Testing For FCC
Submissions/
Verifications

CORRESPONDENCE

To: Katie Hawkins **Date:** March 24, 1999
Company: FCC Application **Pages:** 3, including this cover sheet.
Processing Branch
From: Bob Marshall
Reference: 98540D **Correspondence No.:** 6771
Subject: Applicant: Thomson Consumer Electronics Inc.
FCC ID: G9H2-6920M
731 Confirmation No.: EA93110
Date of Original E-Mail: 03/23/99

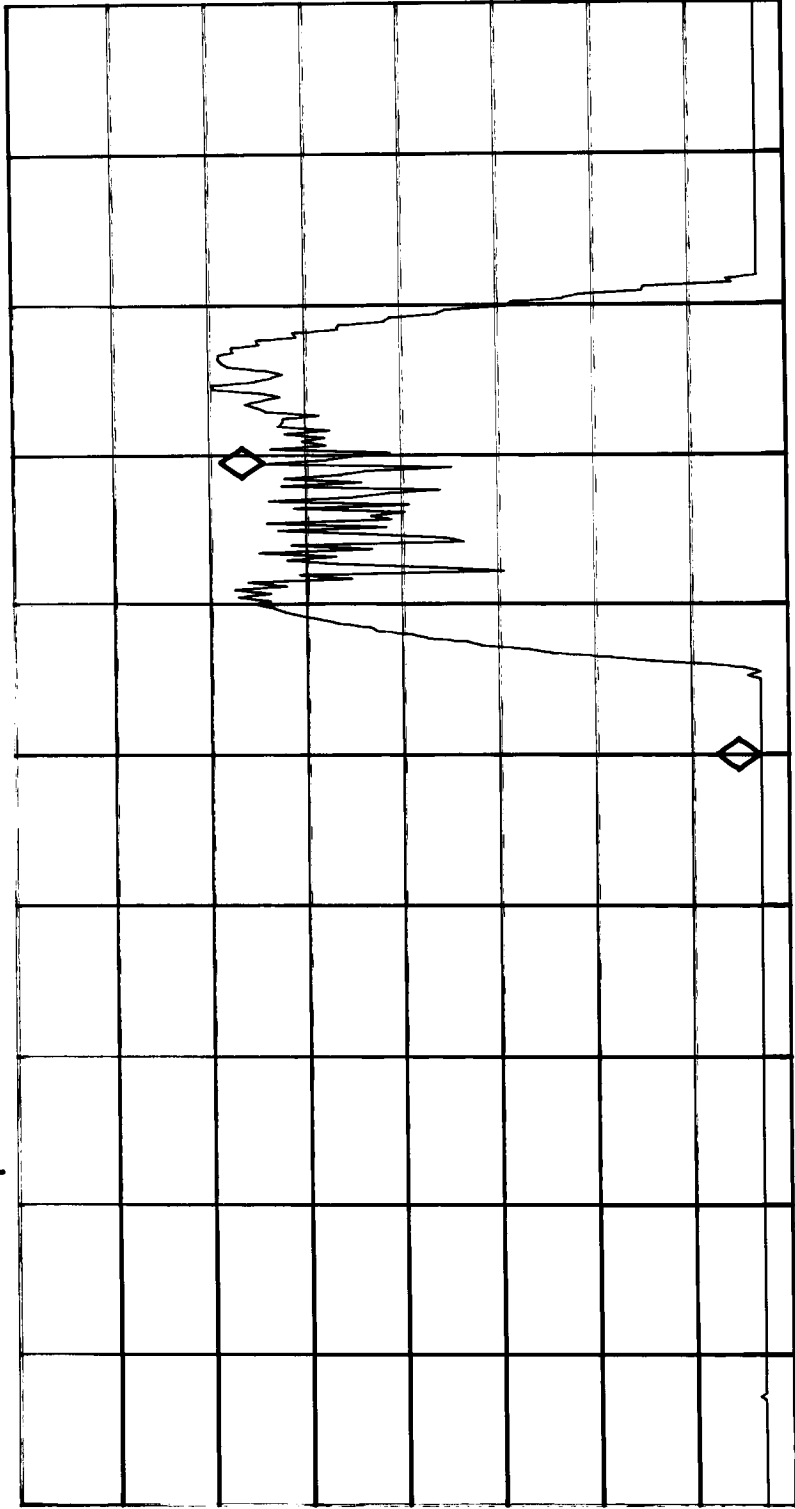
Also, please note that the carrier originally reported at 902.000 MHZ was in error. The correct frequency is 902.1 MHZ as shown in the band edge plot. There are no signals outside the 902.000 to 928.000 band.

The bandwidth plots showing compliance at the band edges have been uploaded via electronic filing.
